SUBJECT: 25-040 Loaf Land Subdivision - Comment Response

Thank you for your continued review of the Subdivision Application Permit (SP 4103) for Loaf Land Subdivision in Coplin Plt.. The team recently received the additional review comments from LUPC in regard to this application, dated August 27, 2026. These comments can be seen below in *italic*, followed by Main-Land's response in regular typeset. Updated or amended exhibits have been provided as attachments.

A1

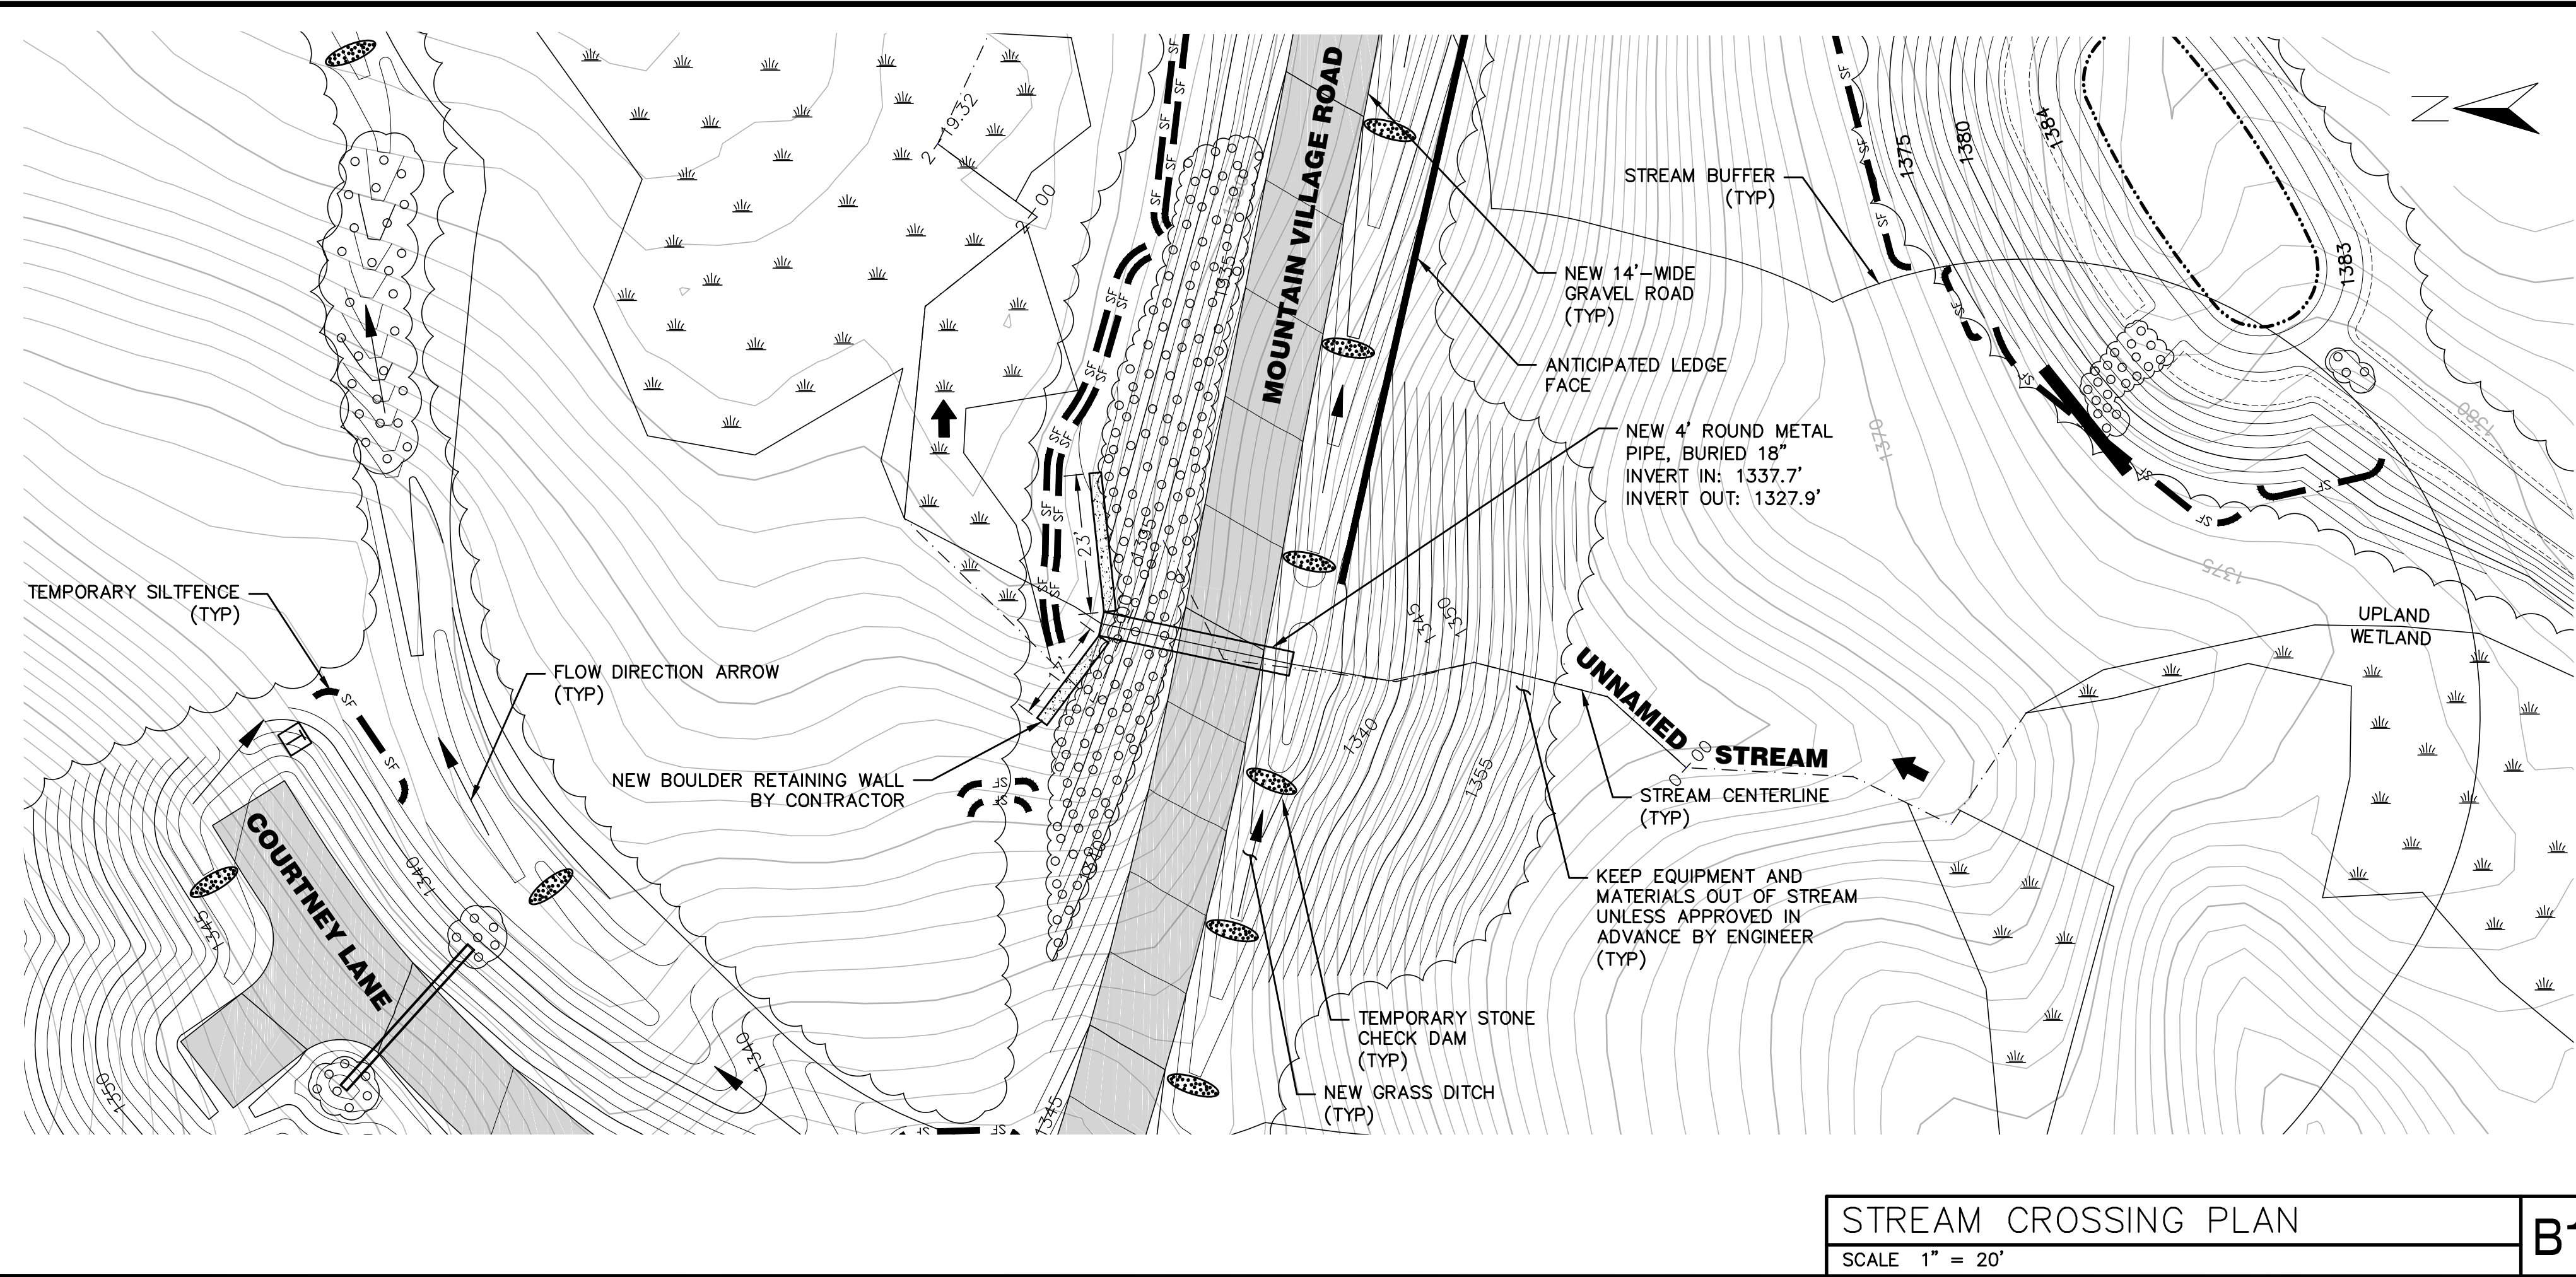
- *On Plan C5.1 (Road Plan and Profile), consider moving the proposed underground electrical conduit to either side of the ditch (see Sebago Technics review comment IV.12 on Sheet C5.1).*
 - *Sebago Response: The proposed electrical conduit is shown running down the centerline of the roadside ditch for Mountain Village Road. The designer should consider moving the conduit to either side of the ditch to avoid shallow cover and water intrusion.*
